STAFF REPORT
COMMUNITY DEVELOPMENT DEPARTMENT

SUBJECT: FP-2020-0018
Ascent Subdivision

B. Final Plat (dated: 12/12/20)

PLAT SHOWING
ASCENT SUBDIVISION
 LOCATED IN THE SE 1/4 OF THE SW 1/4 OF SECTION 10,
 T.3N., R.1W., B.M., CITY OF MERIDIAN, ADA COUNTY, IDAHO
 2021

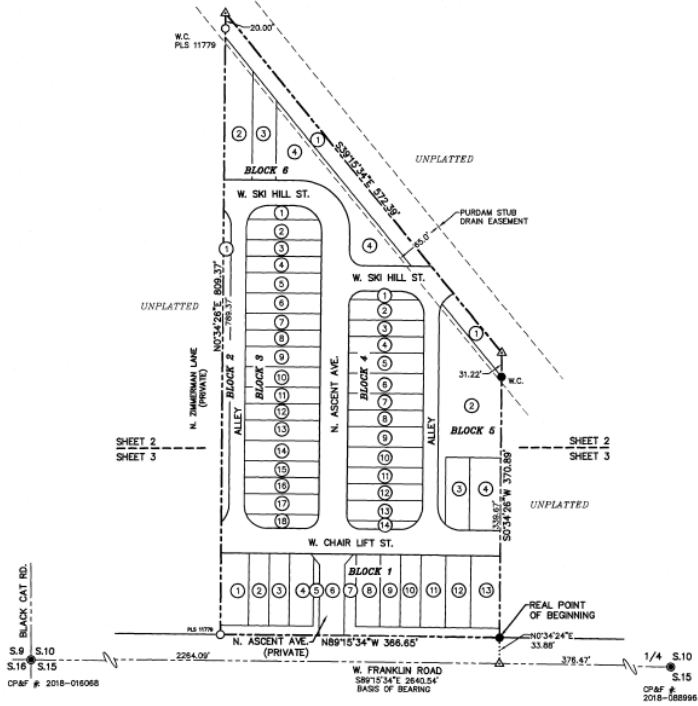
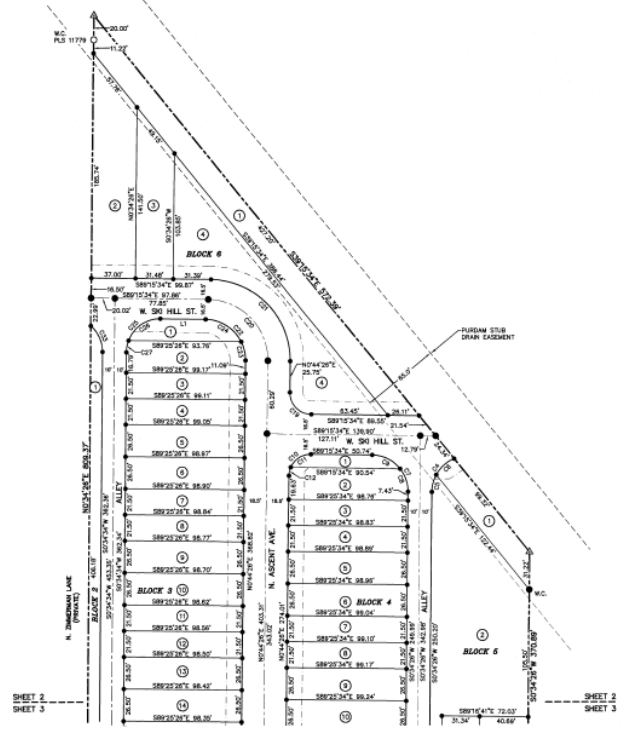
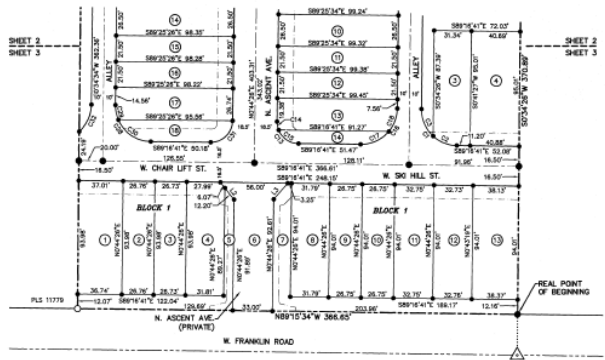
3. Prior to submittal for the City Engineer's signature, have the Certificate of Owners and the accompanying acknowledgement signed and notarized.
4. The final plat prepared by Idaho Survey Group, LLC stamped by Gregory G. Carter, dated: 12/12/2020, included in Section V.B shall be revised as follows:

- a. Graphically depict/call-out a temporary right-of-way easement via W. Franklin Rd. over the common lot (Lot 6, Block 1) instead of a "private" street. Include a note stating this easement shall be released when a local street connection is constructed to this site from a neighboring development; at such time, access will be restricted to emergency and pedestrian access only.

- b. Include a note stating the front yard of each individual lot shall be landscaped with a combination of lawn, groundcover, shrubs and trees as set forth in the TMISAP (see pg. 3-37); the Homeowner's Association shall be responsible for the maintenance of all landscaping on individual homeowner lots as set forth in the Development Agreement (Inst. #2020-110269).

- c. Depict zero lot lines on shared lot lines where structures are proposed to span across lot lines.
 - d. Include a note that prohibits direct lot access via W. Franklin Rd., other than emergency access, once local street access is available from an adjacent property.

- e. Revise plat note #2 to read Nampa & Meridian Irrigation District instead of the City of Meridian.
 - f. Add a note stating "The bottom of structural footing shall be set a minimum of 12-inches above the highest established normal ground water elevation."

- g. Add a note stating "Maintenance of any irrigation and/or drainage pipes or ditches crossing a lot is the responsibility of the lot owner unless such responsibility is assumed by an irrigation/drainage entity or lot owner's association."

Ascent Subdivision	Drawing No: KP-1814 Date: 26/03/2020 Scale: To Fit		Structure Size: 16'3" x 16'2" x 11' Recommended Use Zone: 28'5" x 28'2" Surface Area: 1092 sq ft	HDPS: 48" Age Group: 3-6 Capacity: 20-24	Recreation Today www.recreatoday.net 800.481.8705
--------------------	--	--	--	--	---

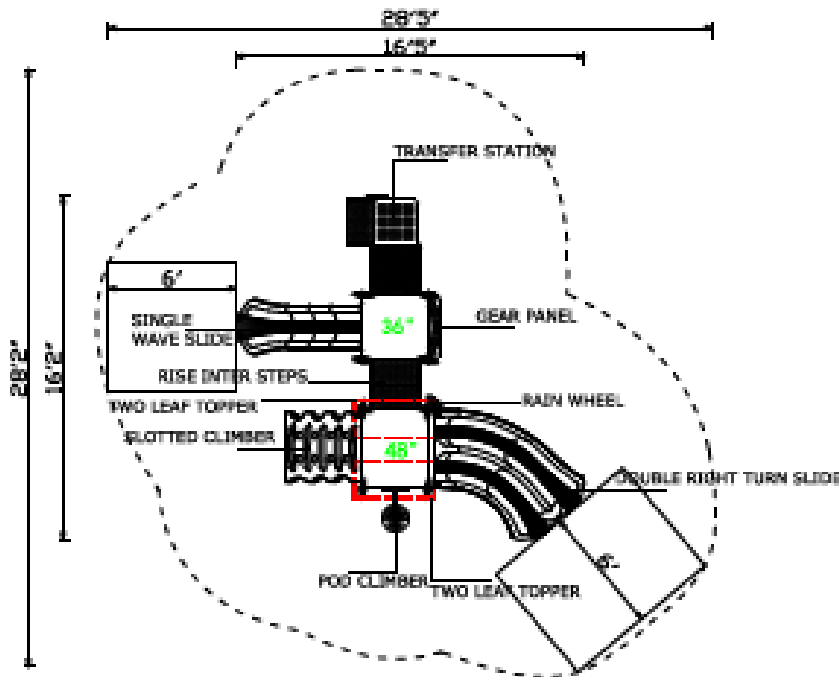
Compliance:
 This play structure has been designed to meet the safety requirements established in:
 • 2010 ADA Standard
 • ASTM F1487
 • CPSC Pub #325
 when the play structure is installed over a properly maintained surfacing material which is in compliance with:
 • ASTM F1292
 • ASTM F1951
 and is appropriate for the highest designated play surface of the structure.
